Packet Guide
City of Charlottesville
Board of Architectural Review
Regular Meeting
August 18, 2026
Hybrid Meeting (In-person at Council Chamber and virtual via Zoom)

BAR #26-0015

BAR # 26-0015

915 East High Street: BAR # 26-0015

Page 16

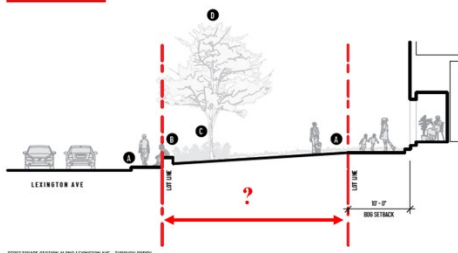
Pg 16. Show the dimension for the wide setback. Even if it's a range due to site variation.

Page 17

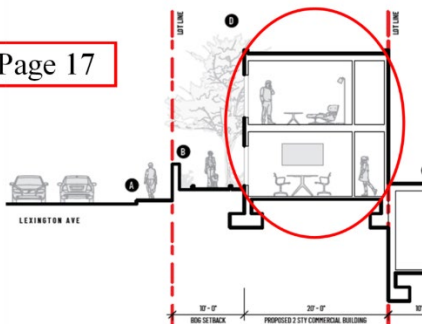
Page 17: Is the two-story structure included for review or shown only as a spatial placeholder?

Page 26

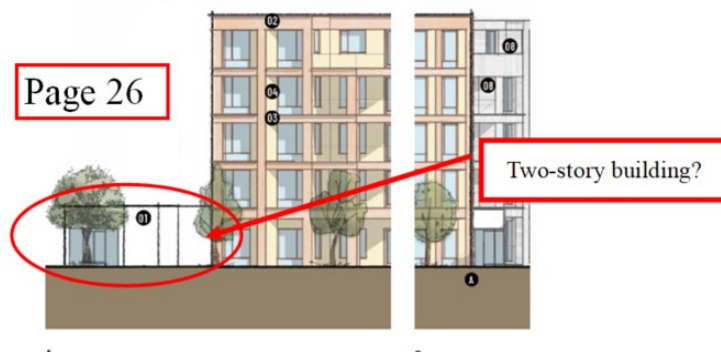
Page 26: Notation for the wood siding on what I assume is the two-story structure. Why is it single-story here?

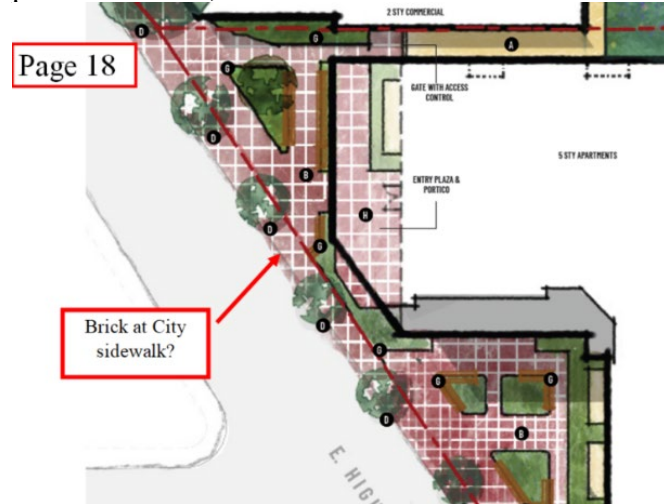
Page 18: Brick walk is shown at the street, in lieu of concrete sidewalk. BAR will not have a problem with it, but will ask if Public Works is OK with it.

Page 19

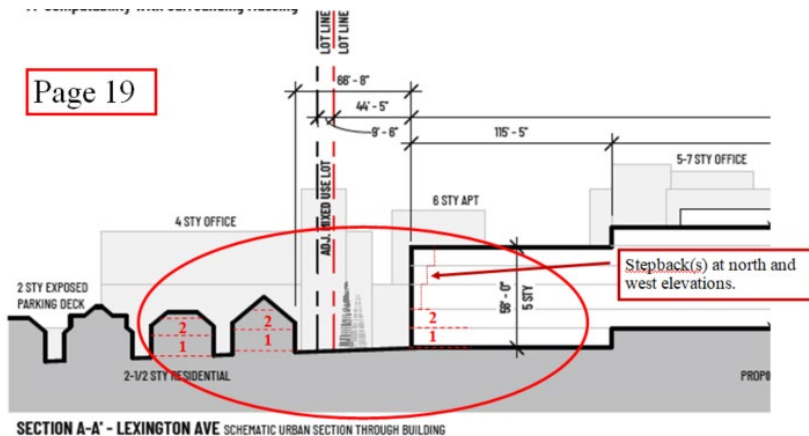
The BAR may accept the overall height, but the guidelines suggest the floor heights of the new correlate with the floor heights of the adjacent houses.

If I had to guess, the BAR will want some reduction at the NW corner. Either a stepback or stepbacks so the building is not five-stories immediately adjacent to the SFDs on Lexington.

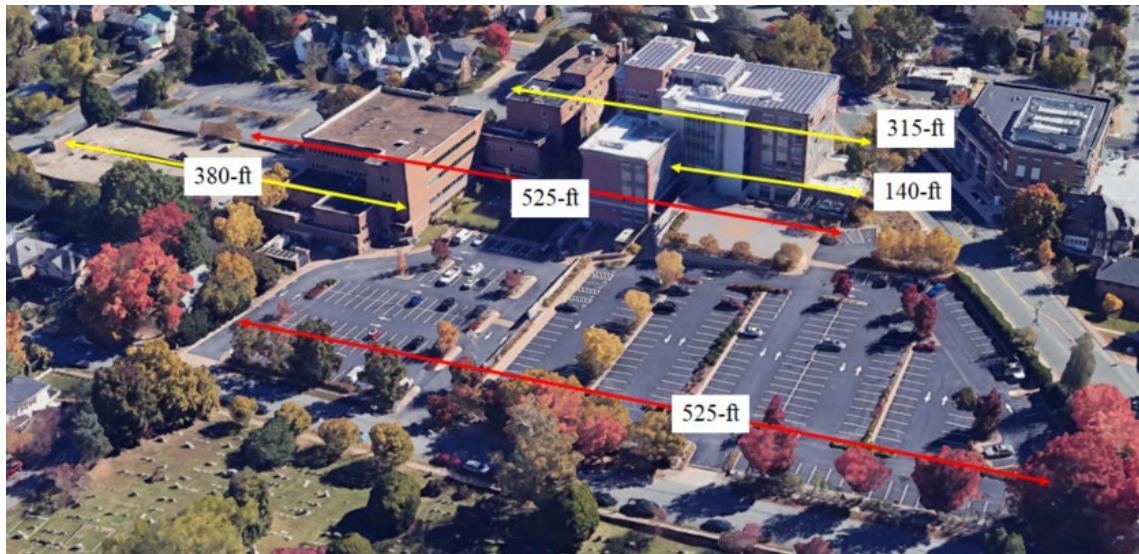
Clarify the retaining walls at the west elevation.
